**ADDENDUM TO THE
LOS ANGELES AERIAL RAPID TRANSIT PROJECT
ENVIRONMENTAL IMPACT REPORT
LOS ANGELES, CALIFORNIA**

October 2026

State Clearinghouse No. 2020100007

Figure 10: Modified LASHP Pedestrian Bridge

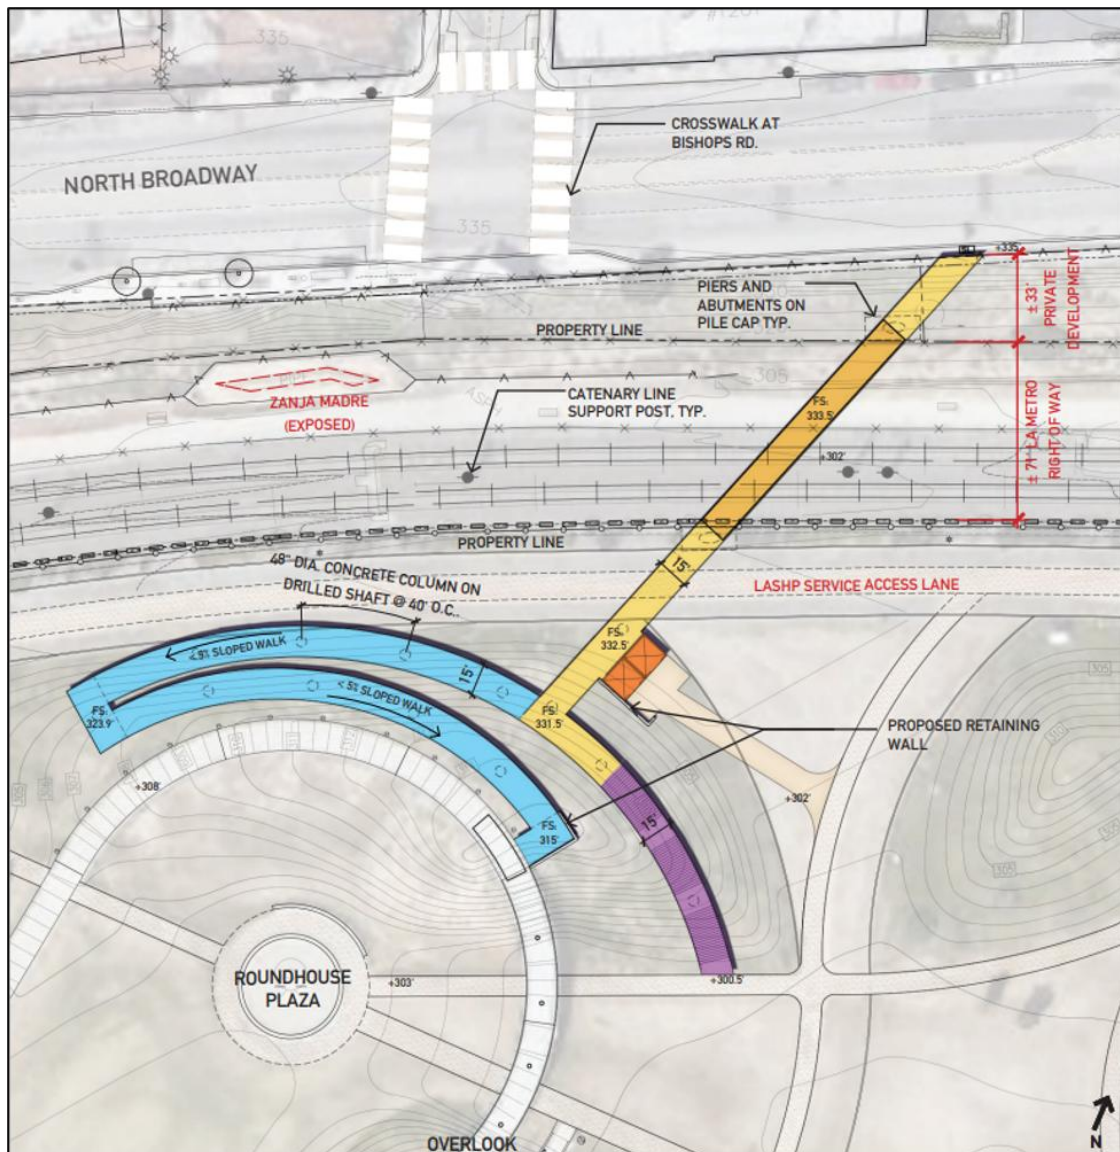
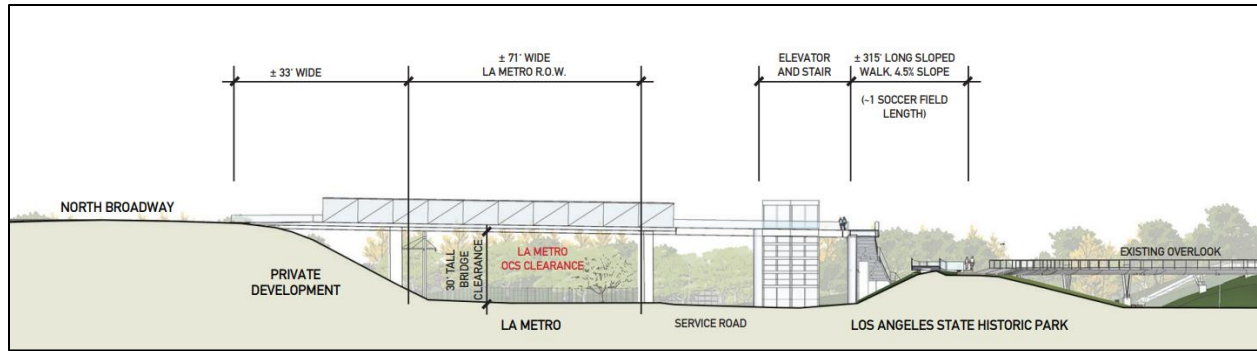
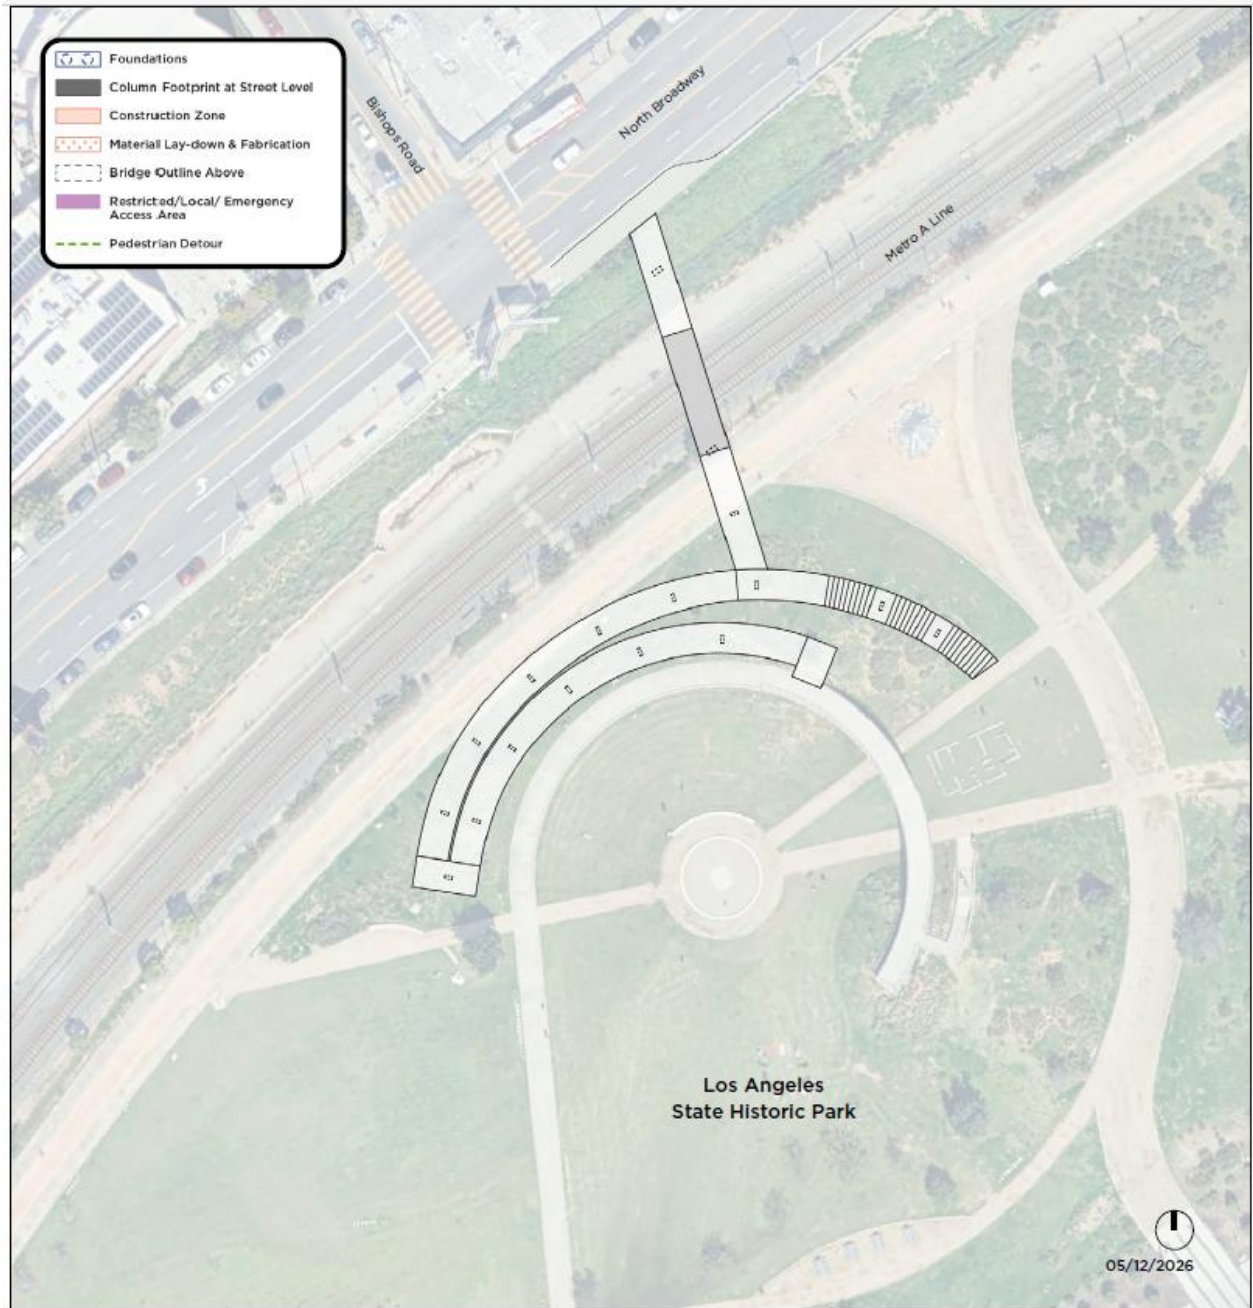
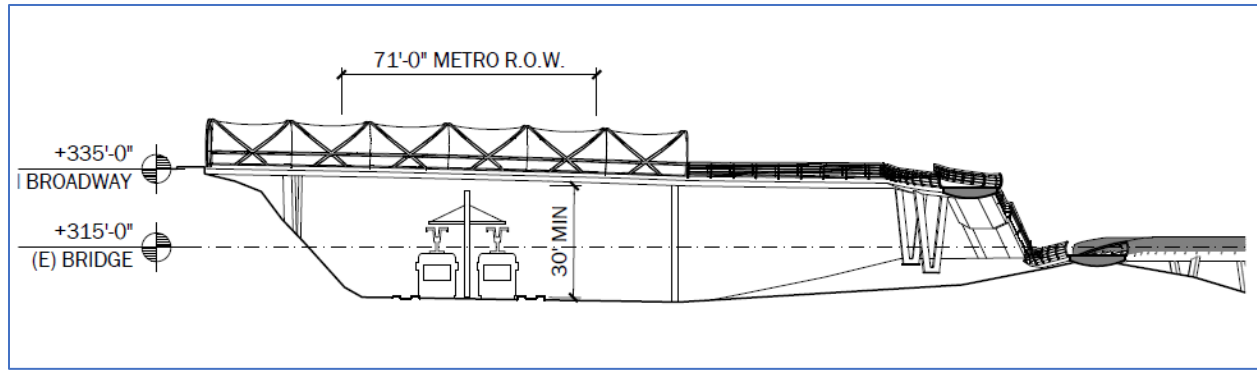
As the engineering and design of the Pedestrian Bridge progressed, it was determined that minor modifications to the Pedestrian Bridge are needed (Modified LASHP Pedestrian Bridge). The Modified LASHP Pedestrian Bridge would generally be located in the same location as the Pedestrian Bridge analyzed in the LA ART EIR.

The Modified LASHP Pedestrian Bridge would result in a smaller construction footprint and shorter construction duration than was identified in the LA ART EIR, and the same construction equipment is anticipated to be needed. See Attachment C for Construction Assumptions for the Modified LASHP Pedestrian Bridge.

It is estimated that the construction of the Modified LASHP Pedestrian Bridge would require approximately 59 weeks of construction, reduced from the 60 weeks of construction in the LA ART EIR. Similar to the LA ART EIR, the Modified LASHP Pedestrian Bridge could be constructed simultaneously with other Project components. It is assumed the Modified LASHP Pedestrian Bridge would include approximately 74 two-to three-foot diameter by 35-to 55-feet deep piles, as compared to the approximately 40 two- to three-foot diameter by 70-feet deep piles assumed for the Pedestrian Bridge in the LA ART EIR. Construction of the Modified LASHP Pedestrian Bridge would require the temporary closure of approximately 52,000 square feet (1.2 acres) of the LASHP during construction, a reduction of approximately 48,000 square feet (1.1 acres) from the 100,000 square feet (2.3 acres) assumed in the LA ART EIR. Approximately 1,371 CY of excavation and 984 CY of material are assumed to be exported, as compared to the 700 CY of excavation and 400 CY of export assumed in the LA ART EIR. If the dirt cannot be spread onsite, the added 584 CY of export could result in approximately 59 additional one-way truck hauling trips during construction. Similar to the Pedestrian Bridge analyzed in the LA ART EIR, it is assumed that during construction, sidewalk closures would be required along North Broadway. Installation of the Modified LASHP Pedestrian Bridge is anticipated to require up to 12 hours of closure for the Metro A Line located under the Modified LASHP Pedestrian Bridge to allow placement of the bridge span. The closure would be coordinated with Metro. No changes to tree removals, compared to what the LA ART EIR considered for the Pedestrian Bridge, are anticipated. The Modified LASHP Pedestrian Bridge would remove approximately 19 trees, consistent with the Pedestrian Bridge analyzed in the LA ART EIR.³ As required by BIO-PDF-F, any trees removed in the LASHP would be replaced by at least a 1:1 replacement ratio. The amount of impervious surface area is anticipated to be unchanged from the Approved Project evaluated in the LA ART EIR.

Approved Project operations would not change as part of the Modified LASHP Pedestrian Bridge. Figure 10 shows the Modified LASHP Pedestrian Bridge buildout, and Figure 11 shows the Modified LASHP Pedestrian Bridge section view. See Figure 12 for a visual simulation of the LASHP Modified Pedestrian Bridge and Figure 13 for an overview of the Modified Park Amenities, Additional Park Improvements, and Modified LASHP Pedestrian Bridge within LASHP.

LASHP Pedestrian Bridge (LA ART EIR Design & Use Option E)	Modified LASHP Pedestrian Bridge
Construction Duration	60 weeks	59 weeks
Excavation	700 CY	1,371 CY
Export	400 CY	984 CY
Piles	40 two- to three-foot diameter by 70-foot deep piles	74 two-to three-foot diameter by 35-to 55-foot deep piles
Construction Area / Temporary Closure	100,000 square feet (2.3 acres)	52,000 square feet (1.2 acres)

Figure 7: LASHP GPA Figure 4-3, Los Angeles Aerial Rapid Transit Project Area

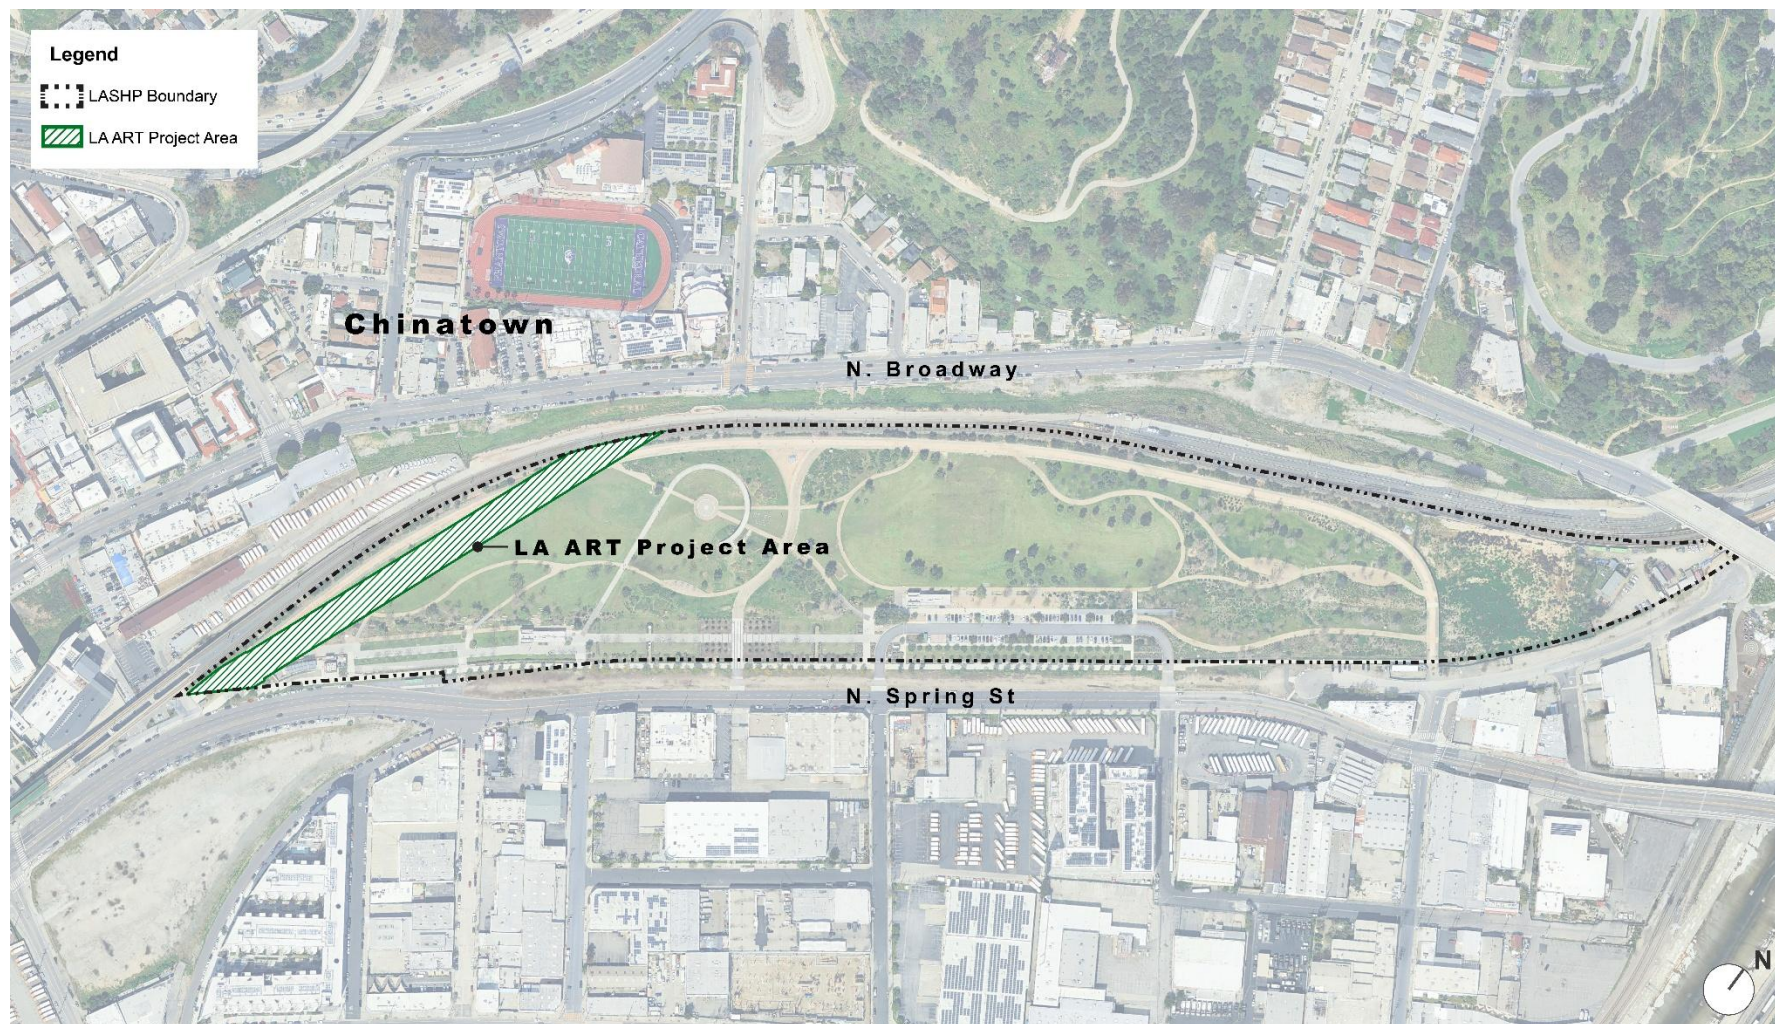
Consistent with Mitigation Measure LUP-A from the LA ART EIR, State Parks is considering an amendment to the LASHP General Plan (LASHP GPA) to include the Los Angeles Aerial Rapid Transit Project Area (LA ART Project Area) as a land use within LASHP to accommodate the development and operation of a portion of the Approved Project. The proposed LASHP GPA is included as Attachment A to this Addendum. See Figure 7 for the LASHP GPA Figure 4-3, Los Angeles Aerial Rapid Transit Project Area.

Figure 8: Park Amenities Area

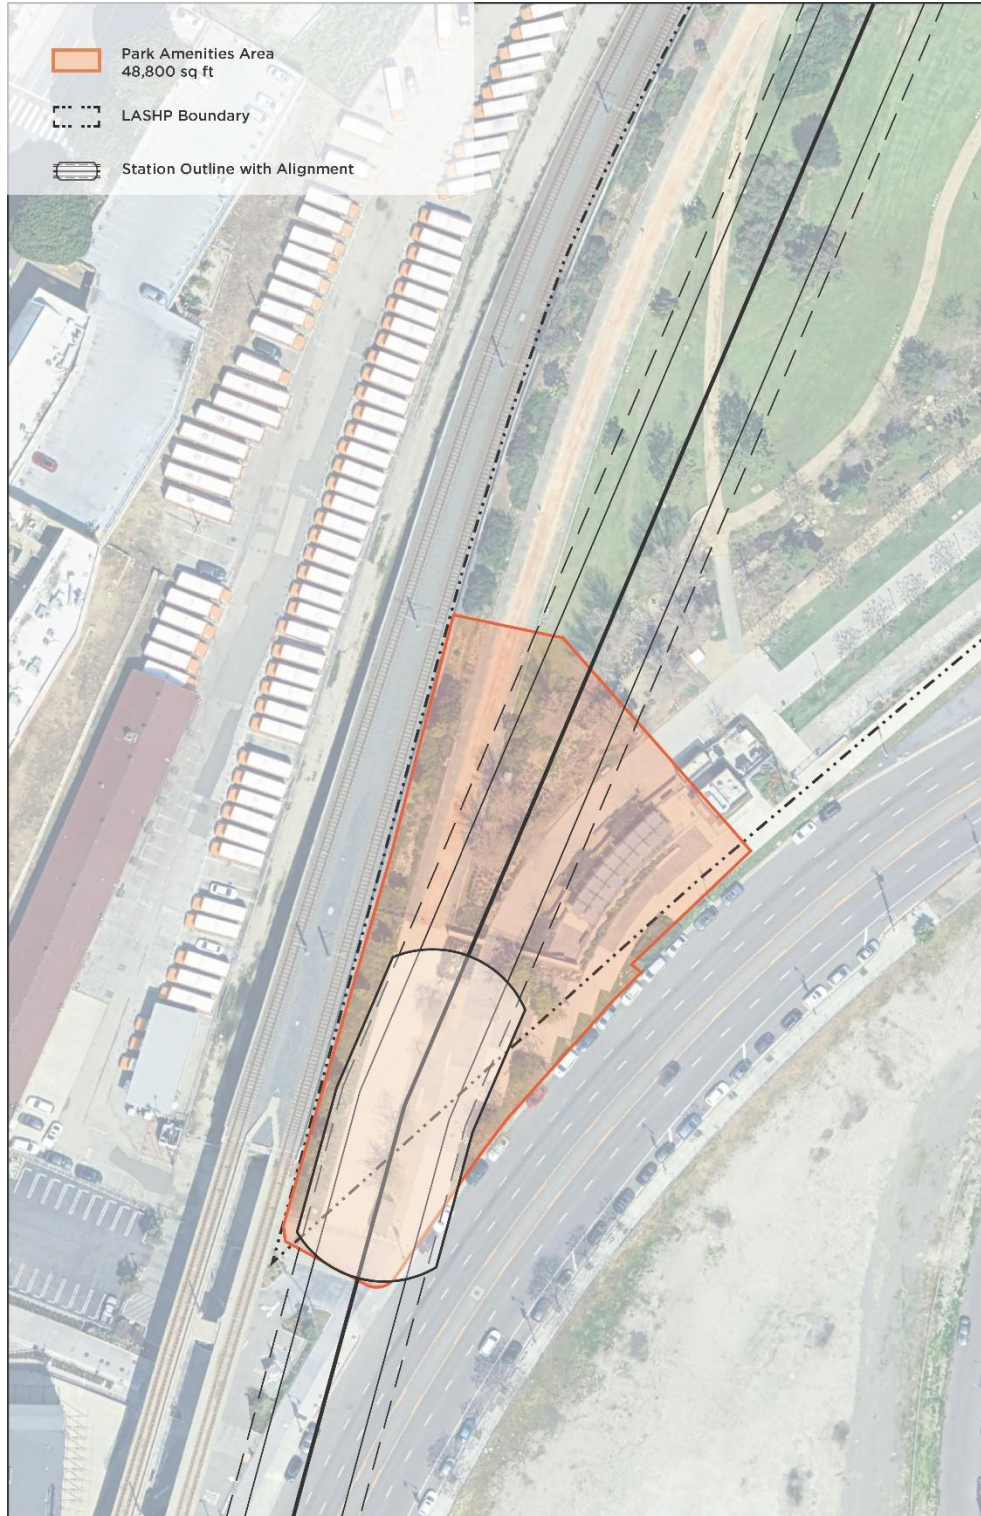
Similar to the Approved Project, the Modified Park Amenities would include approximately 740 square feet of concessions or another similar amenity building, 770 square feet of restrooms, and a 220 square foot covered breezeway connecting the concessions or other similar amenity building and restrooms. Depending on the final design, the location and layout of these buildings and the covered breezeway may shift slightly, but the square footage and general location will remain the same as the Approved Project.

The location of the Modified Park Amenities is in the same location as the Approved Project Park Amenities (Park Amenities Area). See Figure 8 for the location of the Park Amenities Area. Similar to the Approved Project, the Chinatown/State Park Station is also located in the Park Amenities Area. There are no changes to the construction or operation of the Chinatown/Station Park Station.

Figure 9: Park Amenities Area and Additional Park Improvements Area

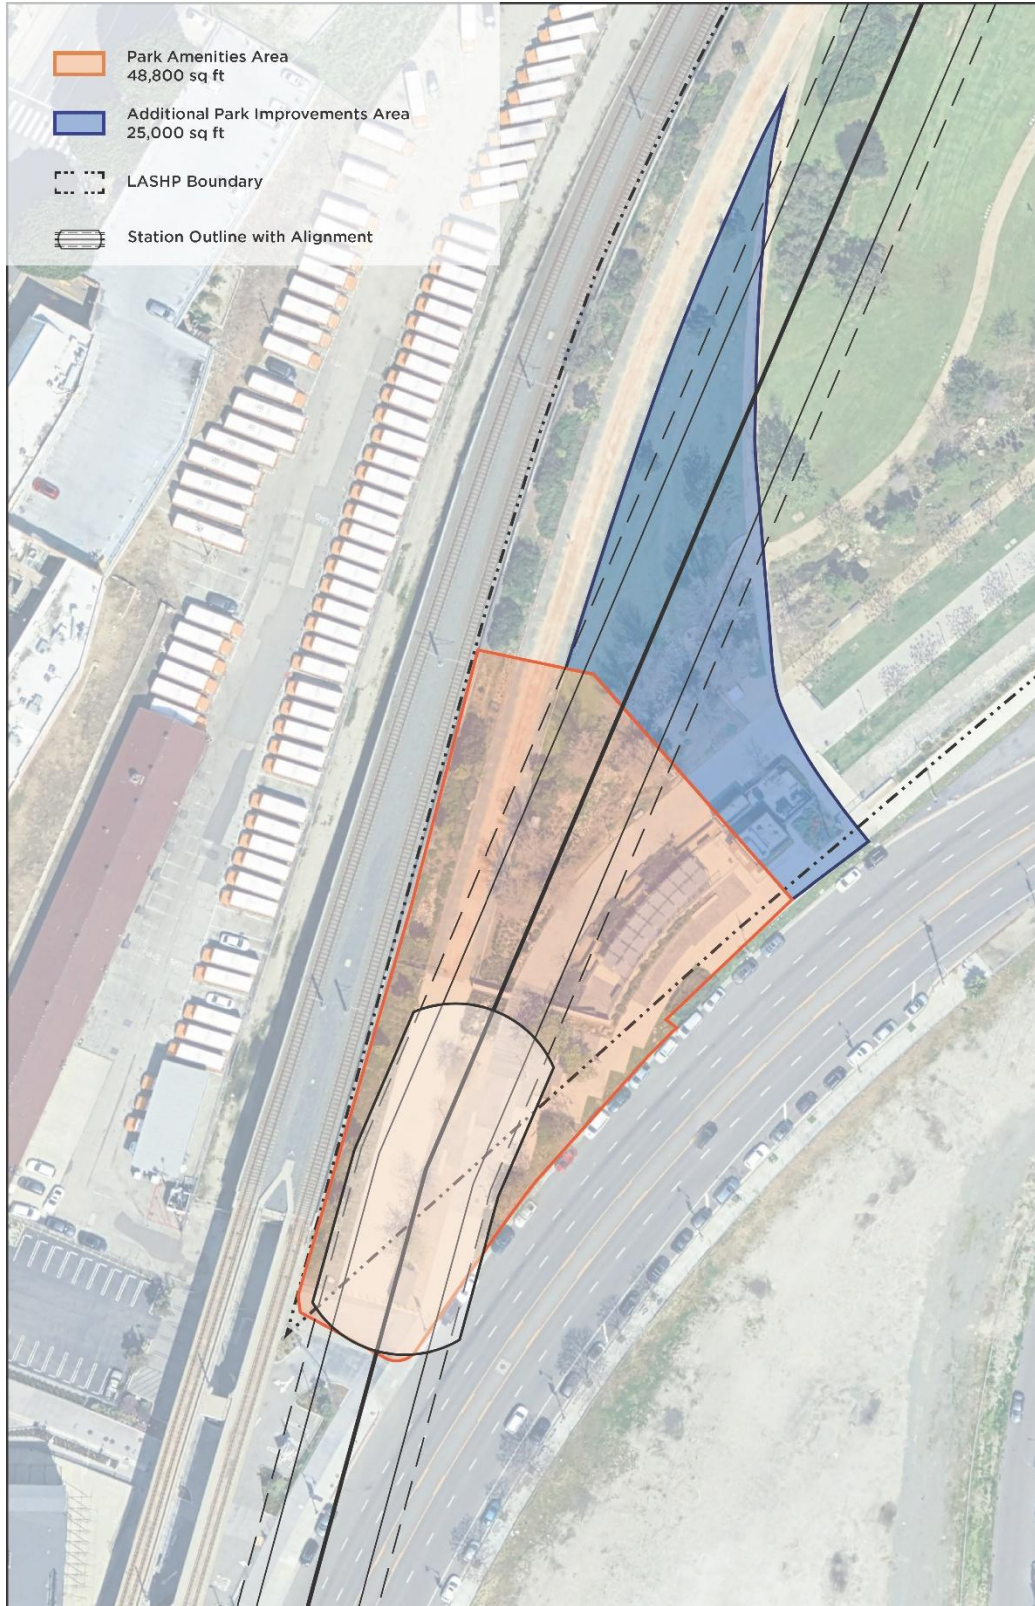
As part of the LASHP GPA process, additional hardscape and landscape improvements and Park amenities within the LASHP have been identified (Additional Park Improvements). See Figure 9 for the location of the Additional Park Improvements Area. The Additional Park Improvements Area is approximately 25,000 square feet (0.6 acres). The Additional Park Improvements may include the following: installation of landscaping and hardscaping, including integration of the granite pavers; new gating for the LASHP entrance; wayfinding signage and lighting; drinking fountains; benches; flexible seating; interpretative children's play zones; temporary art installations; interactive LASHP kiosks; a cultural activities area; an outdoor educational center; and similar LASHP amenity spaces. It is anticipated that these features are similar in size and scale to those considered in the LA ART EIR.

It is estimated that installation of the Additional Park Improvements would require approximately 16 weeks of construction and would be constructed simultaneously with the Modified Park Improvements within the Park Amenities Area. The Construction Assumptions for the Additional Park Improvements are included in Attachment B of this Addendum. Installation of the Additional Park Improvements would require approximately 504 CY of excavation and 247 CY of export and would result in similar impervious surface areas. The added 247 CY of export could result in approximately 25 additional one-way truck hauling trips during construction. The construction equipment for the Additional Park Improvements would be similar to the equipment for the Approved Project Park Amenities. No new tree removals would be required for the Additional Park Improvements other than those identified in the LA ART EIR.
